Colorado Springs, CO

Final Report - Corrections Required **Application No. DEPN-26-0063**

Description : Single Family Detached residential development located north of New Life Drive in the Flying Horse Master Plan

Document Filename : DP Creekridge at Flying Horse Filing No 1.pdf

TITLE SHEET
MAY 2026

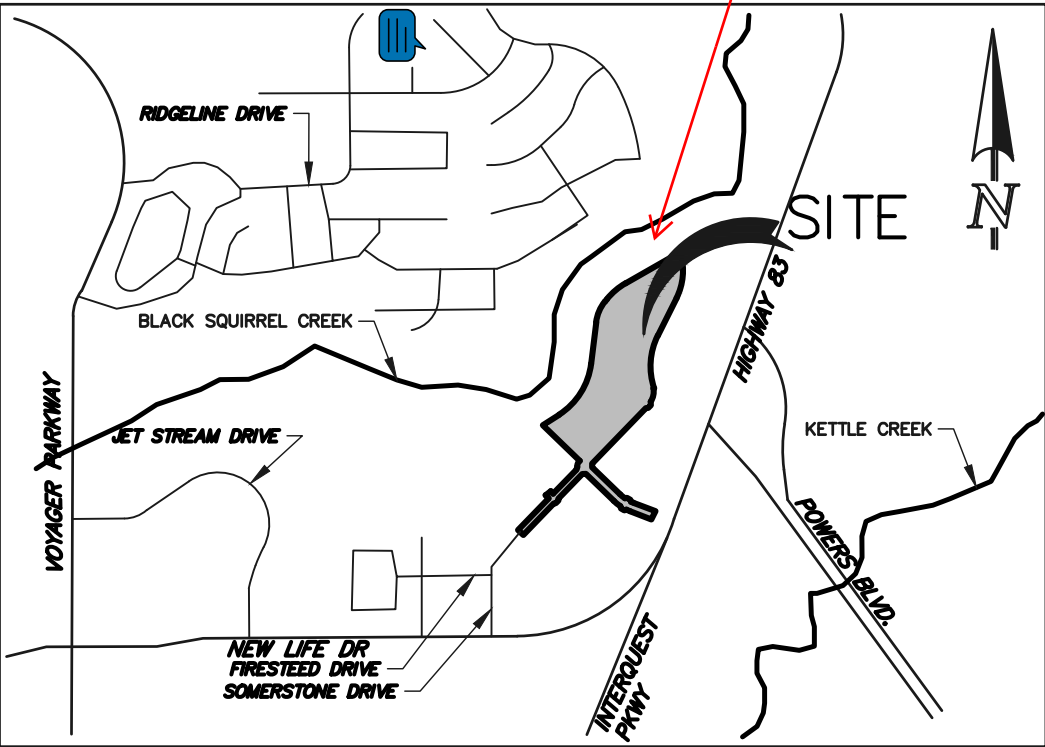
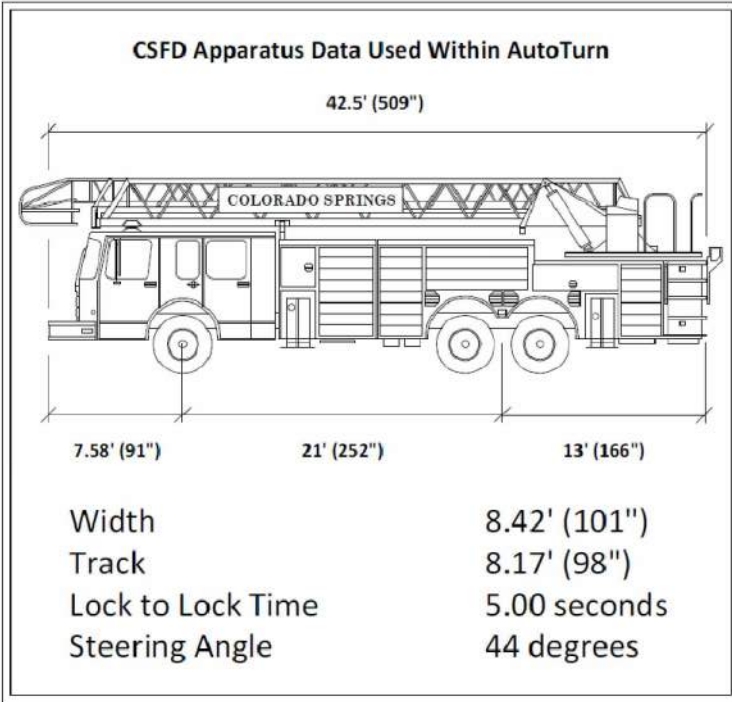
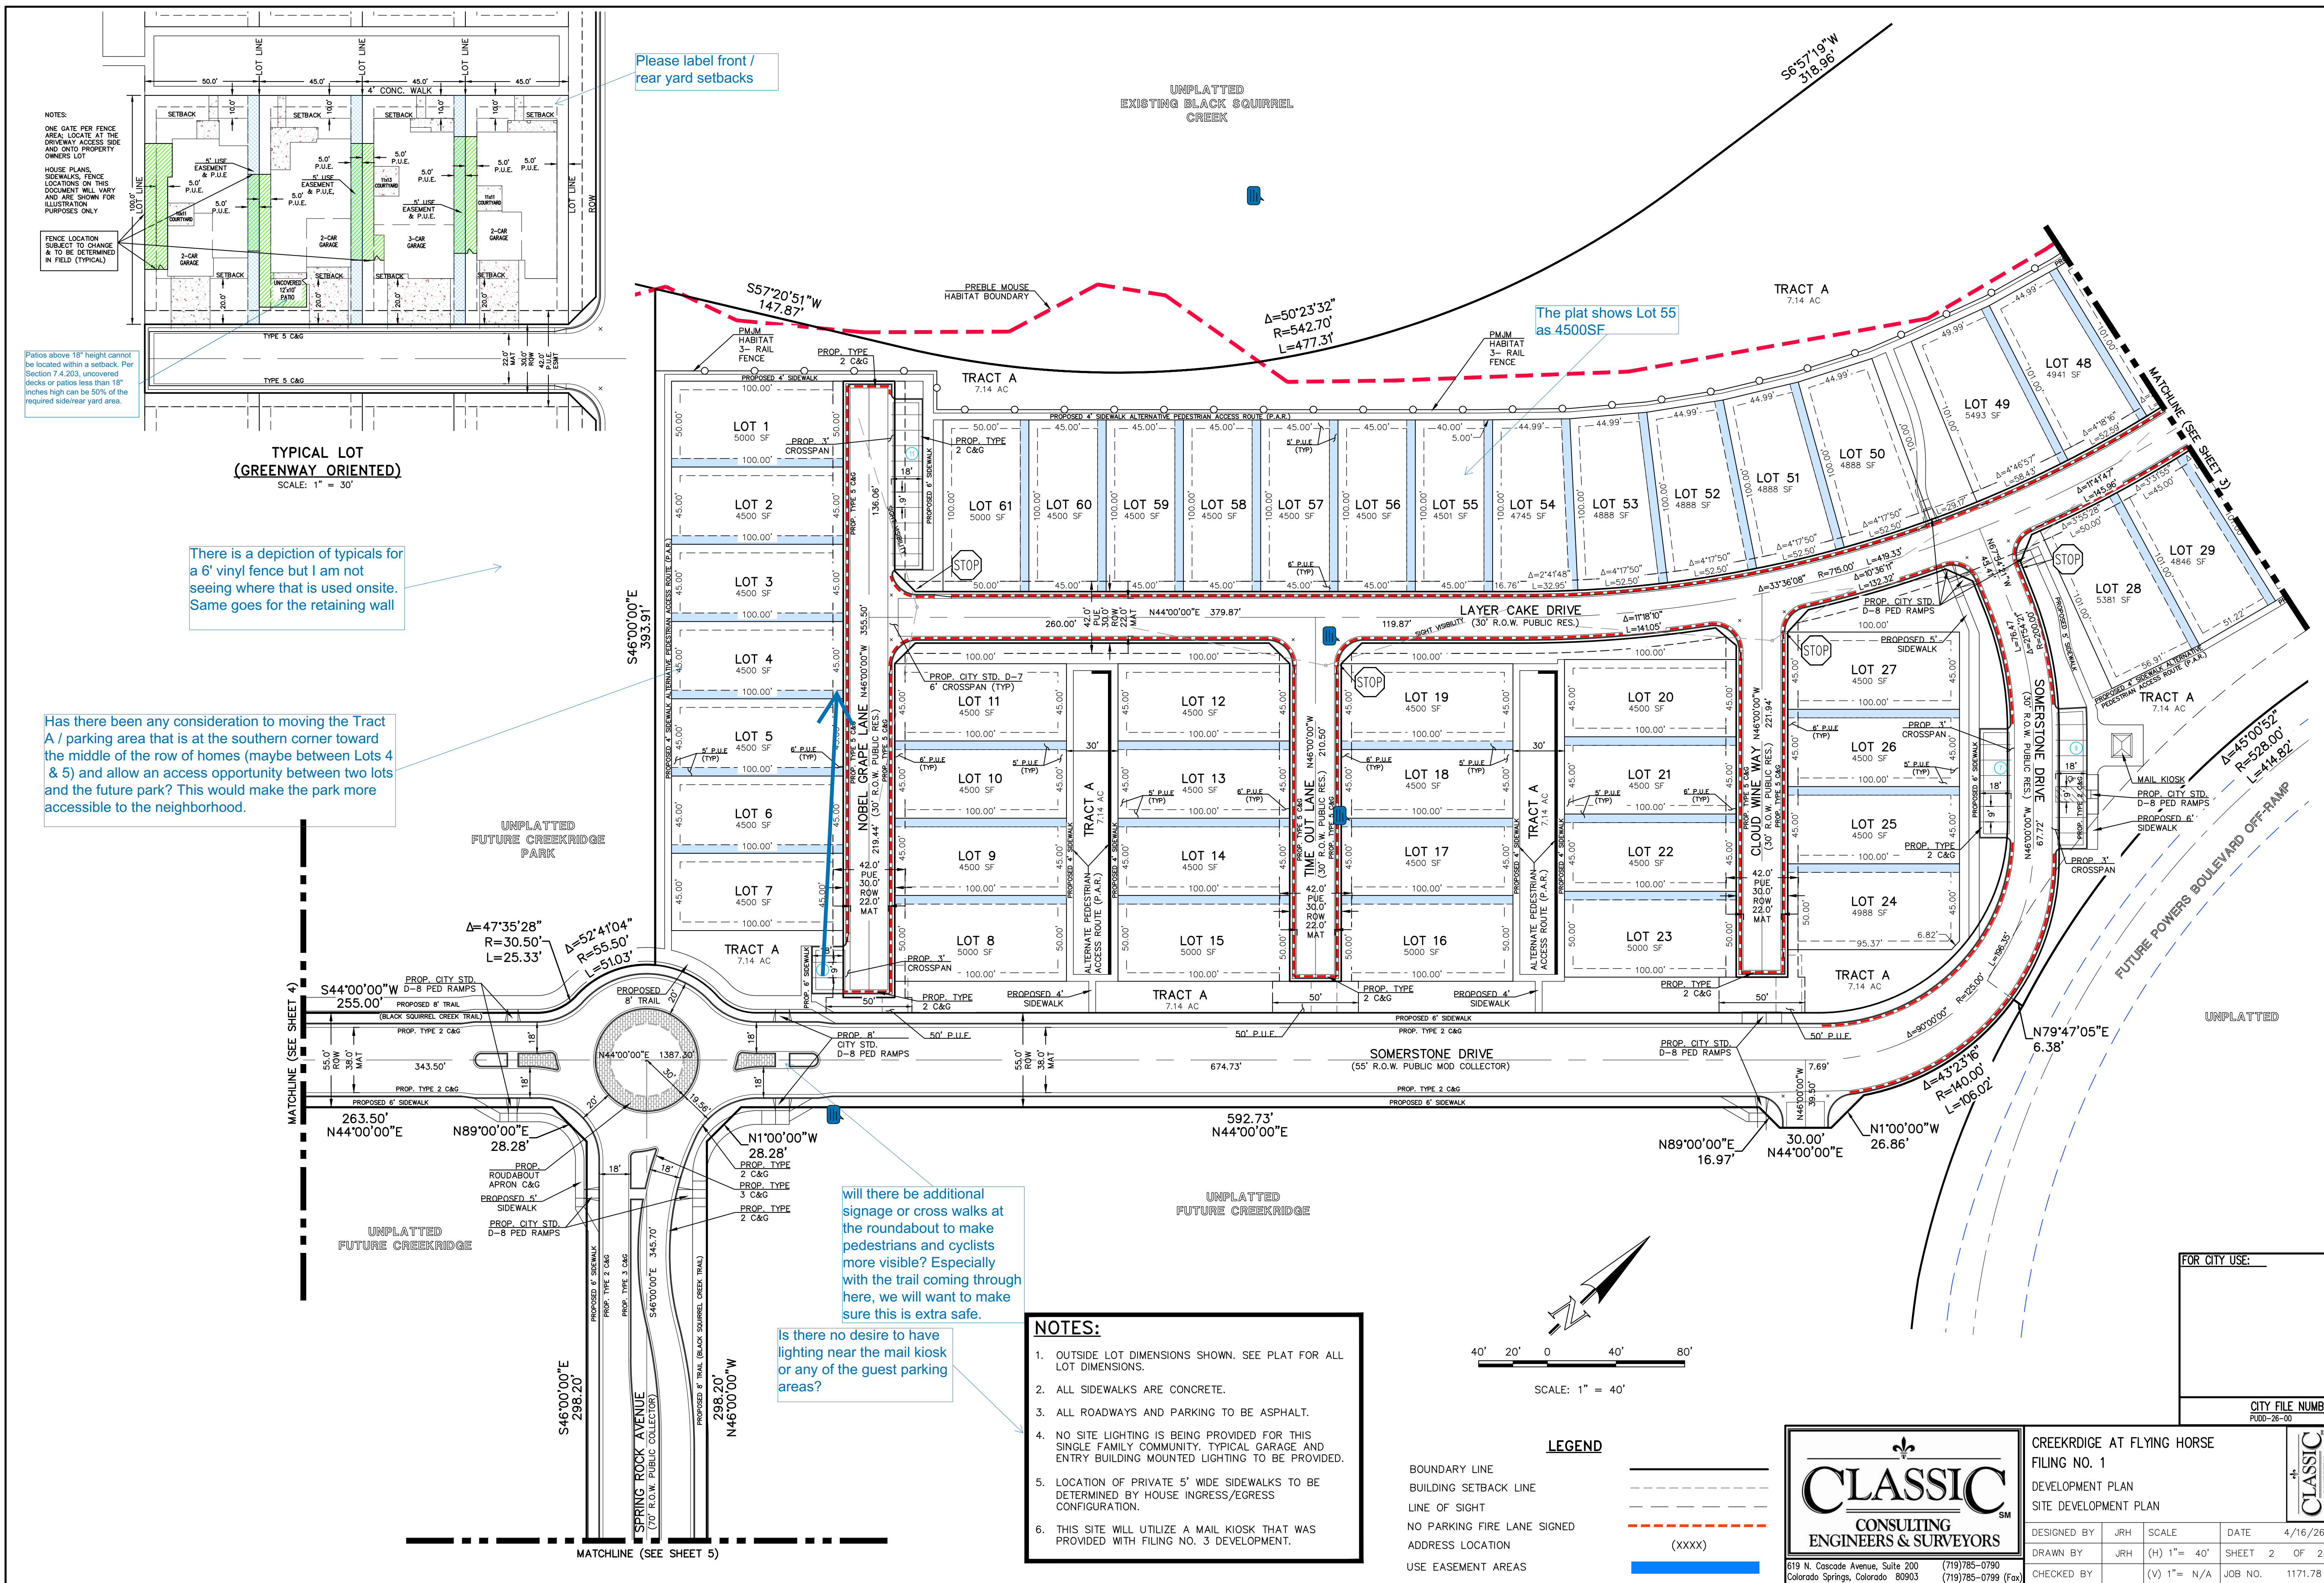
SWENT may have additional comments on this DP once additional information is provided in the FDR and a channel site visit has taken place.

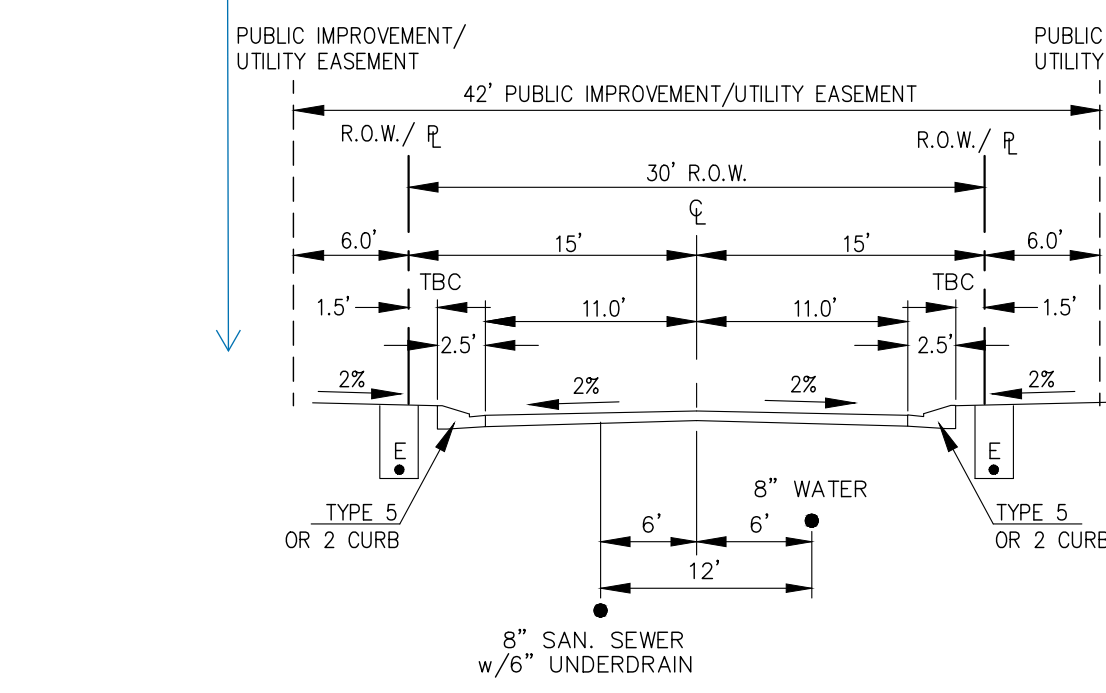
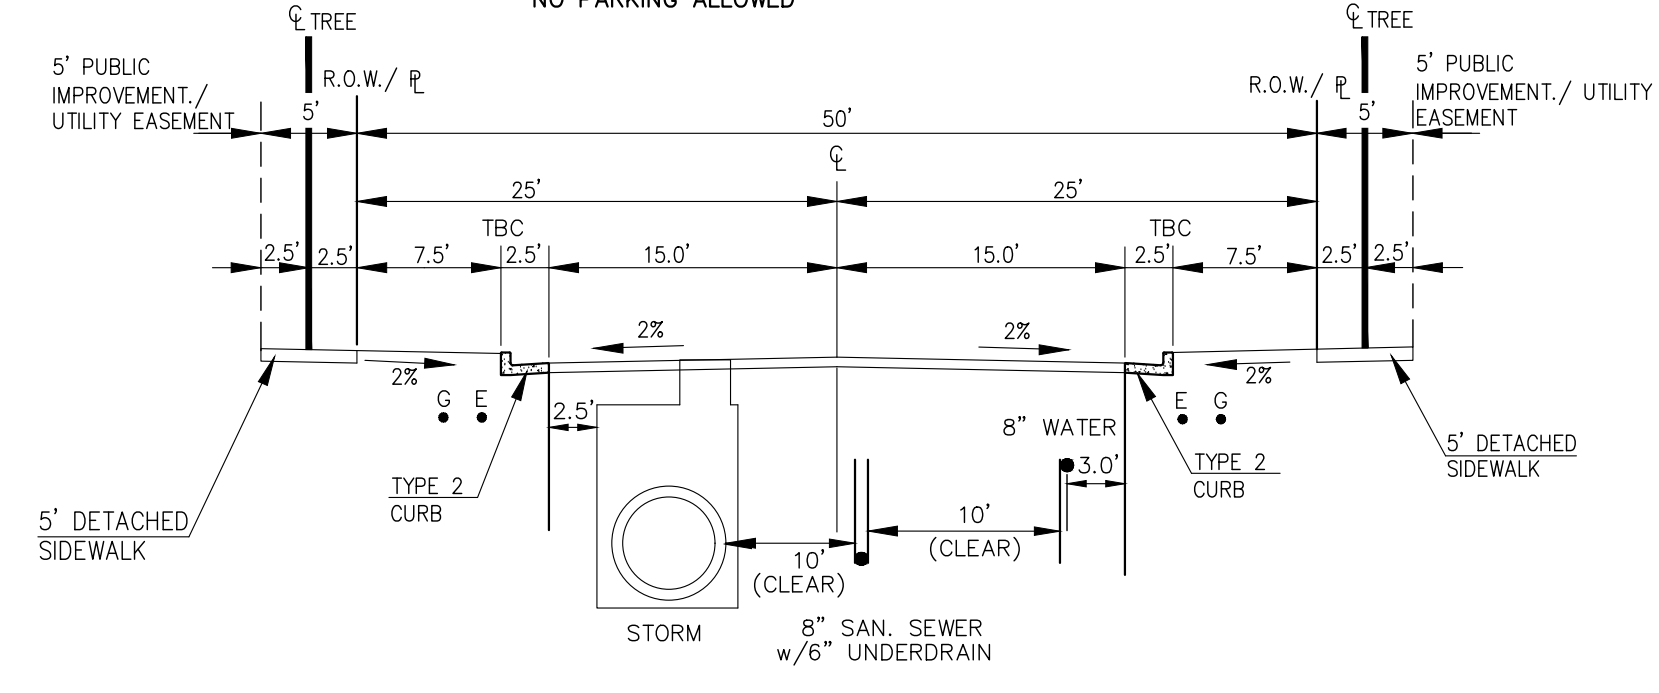
is there any intention to
build sound walls along the
proposed off-ramp?

What is this dashed
line?

Sound walls?

There is a mail kiosk
already shown on this
plan?

Plat shows the radius
as 60'

Please confirm that the off-ramp is in alignment with the construction drawings for the
Powers improvements

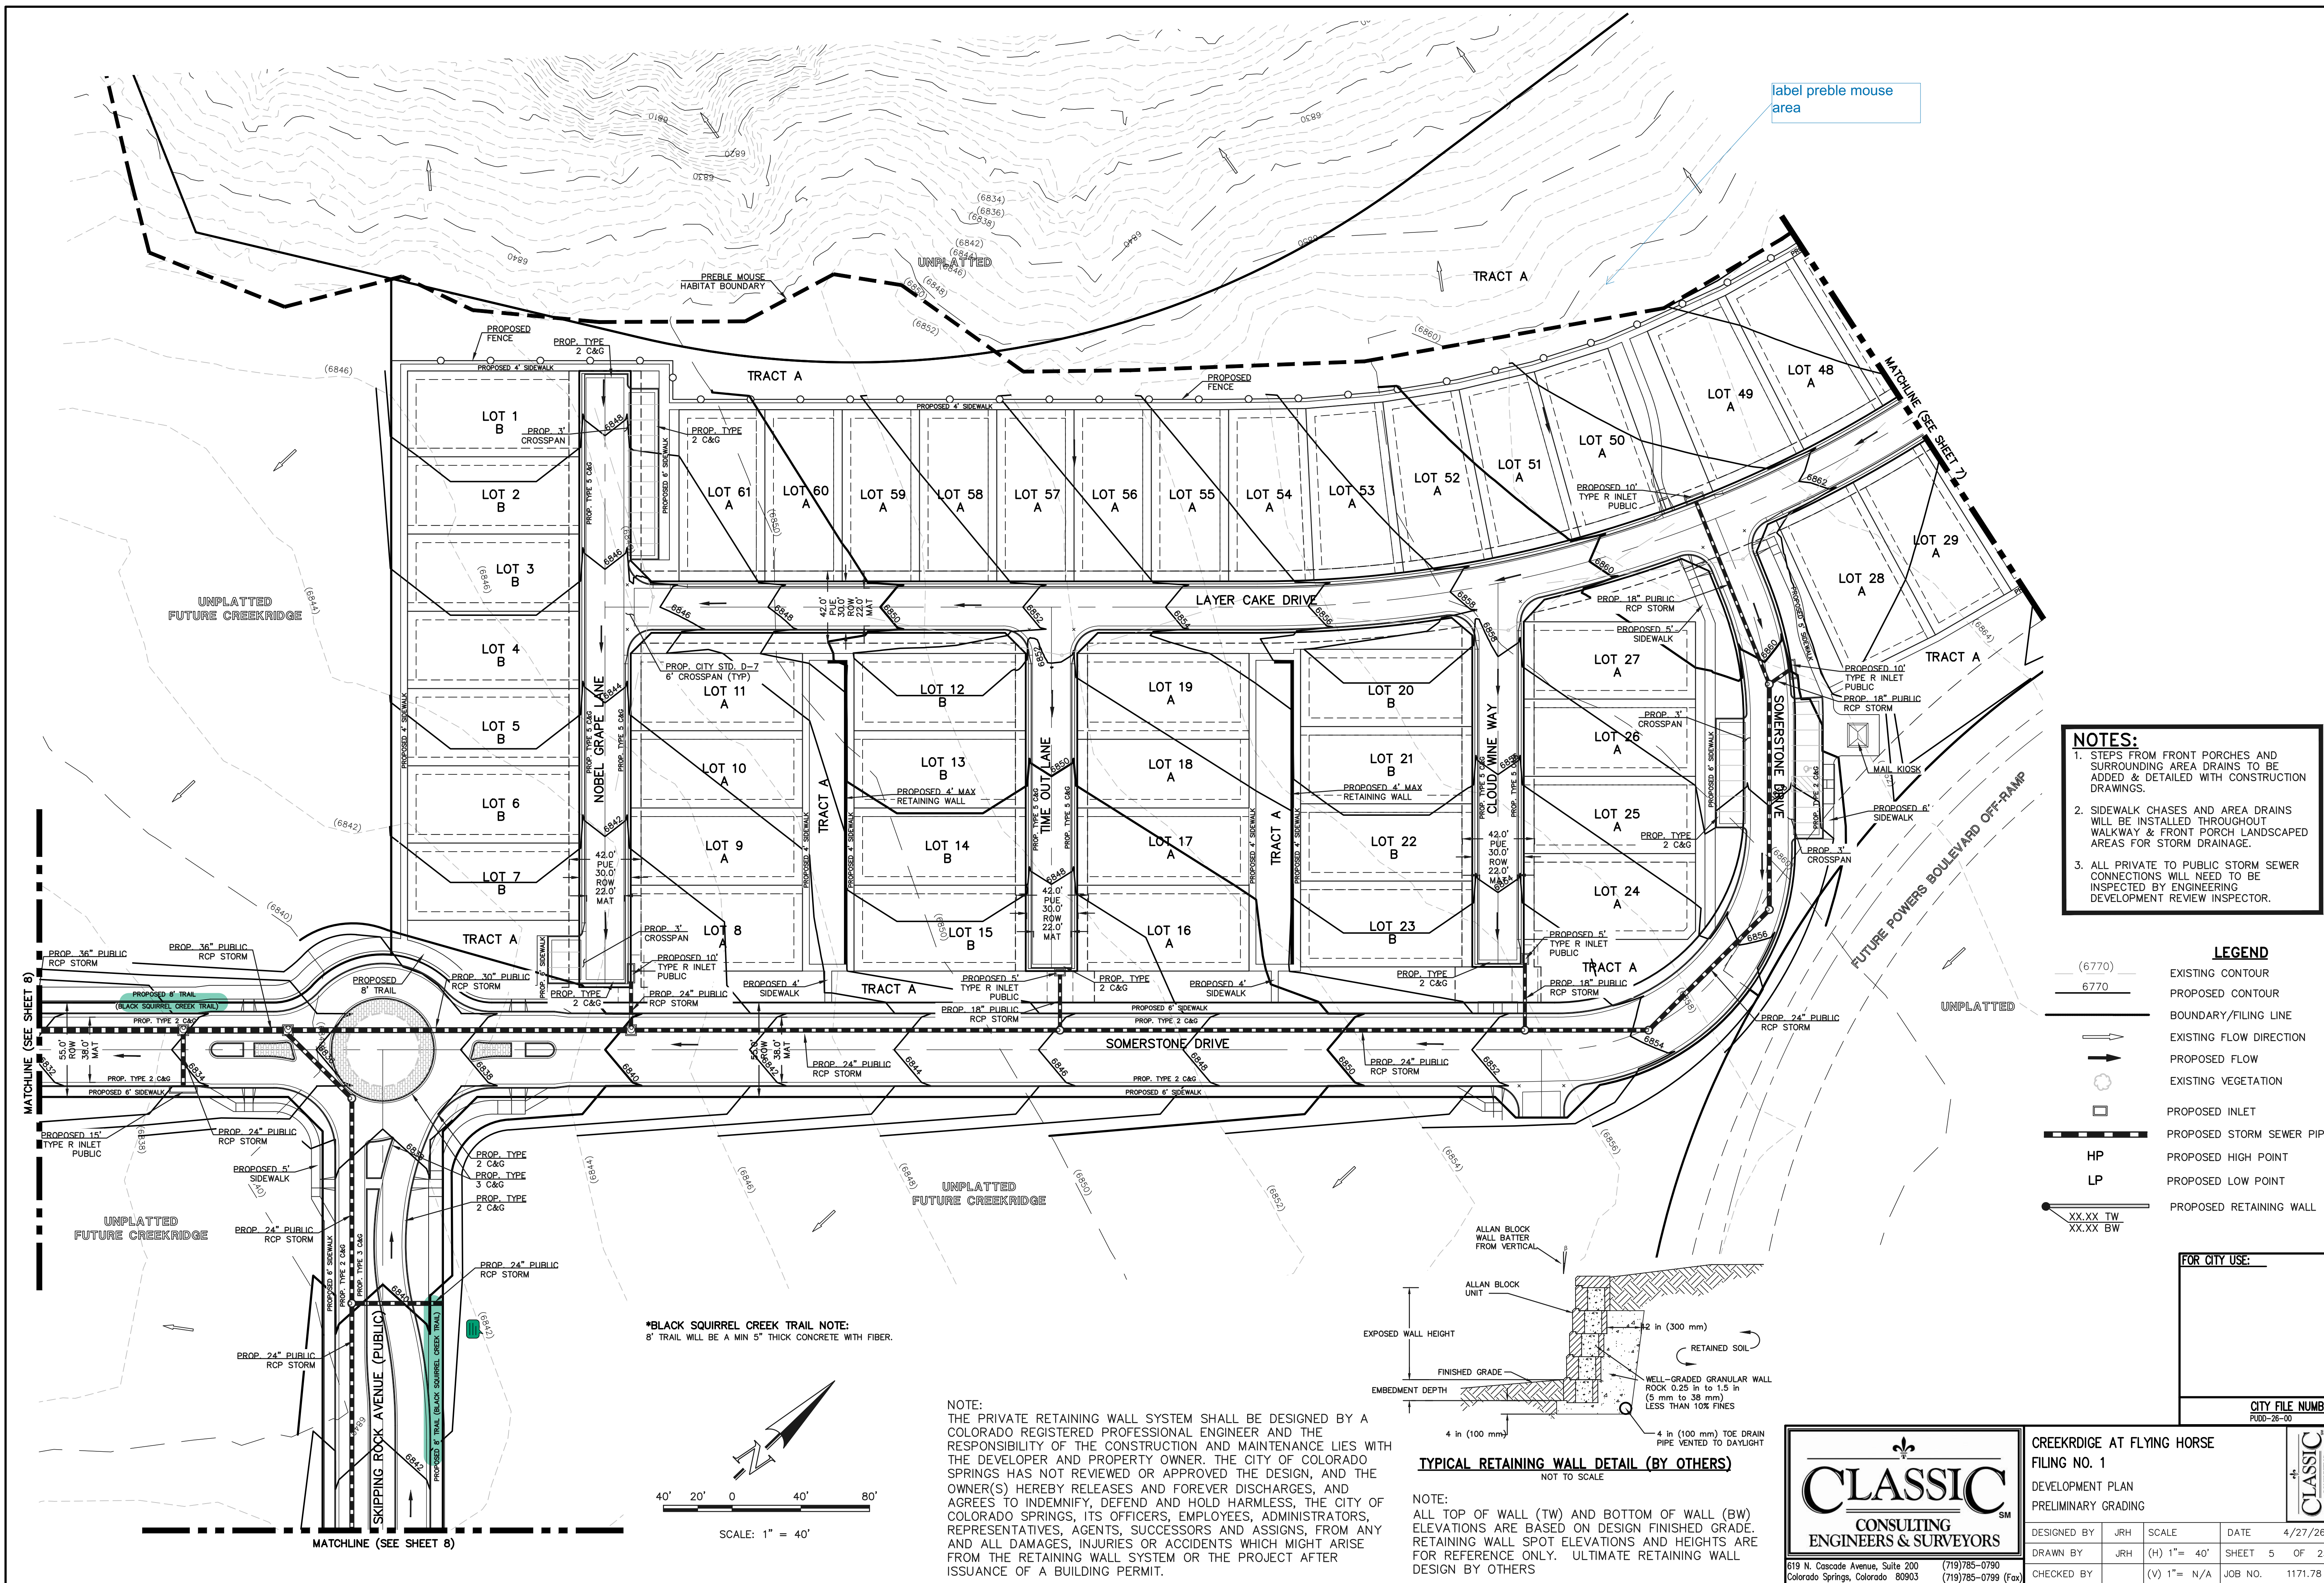
label preble mouse area
